UNITED STATES PATENT AND TRADEMARK OFFICE

APPLICATION NO.	FILING DATE	FIRST NAMED INVENTOR	ATTORNEY DOCKET NO.	CONFIRMATION NO.
10/028,050	12/20/2001	Nikolaos V. Tsekos	600.466US2	4434
21186	7590	09/17/2004	EXAMINER	
SCHWEGMAN, LUNDBERG, WOESSNER & KLUTH, P.A. P.O. BOX 2938 MINNEAPOLIS, MN 55402			SHAW, SHAWNA JEANNINE	
			ART UNIT	PAPER NUMBER
			3737

Office Action Summary	Application No. 10/028,050	Applicant(s) TSEKOS	
	Examiner Shawna J. Shaw	Art Unit 3737

Figure 3A of the present application demonstrates a stage (126), coupled to probe guide (33) and first and second compression surfaces (104, 106) and adapted to rotate on a second axis substantially orthogonal to the first axis (as depicted by arrow 128):

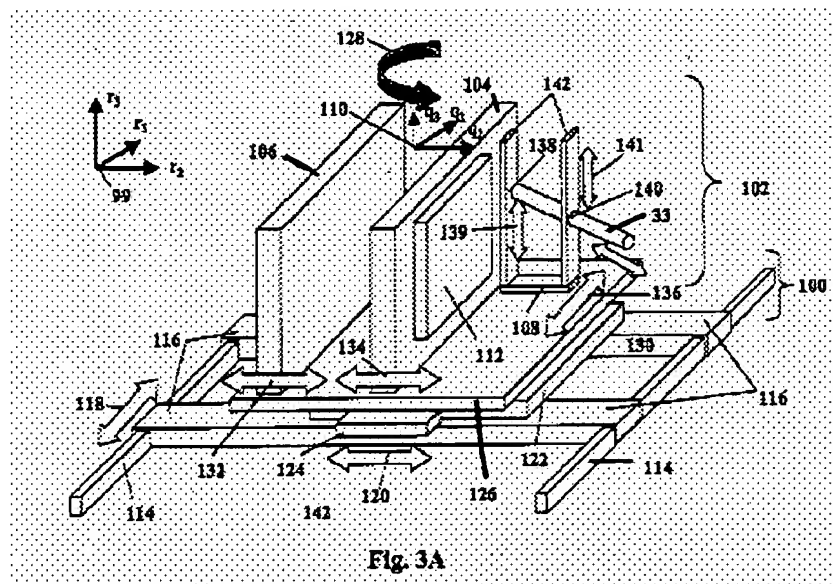
1. Applicant's arguments filed 06/18/2004 have been fully considered but they are not persuasive. Regarding claims 27-43, 48 and 51-56, the examiner maintains that Siczek et al. disclose a stage/platform (130) coupled a probe guide (132) and first and second compression surfaces (128, 126) and adapted to rotate on a second axis substantially orthogonal to the first axis (col. 11 lines 46-49), as recited in claims 27 and 51. Since applicant is not able to discern the recited element(s) in the figures and detailed description of Siczek, the examiner will refer to figures 7 and 12A of the cited patent as compared with figure 3A of the applicant's present invention:
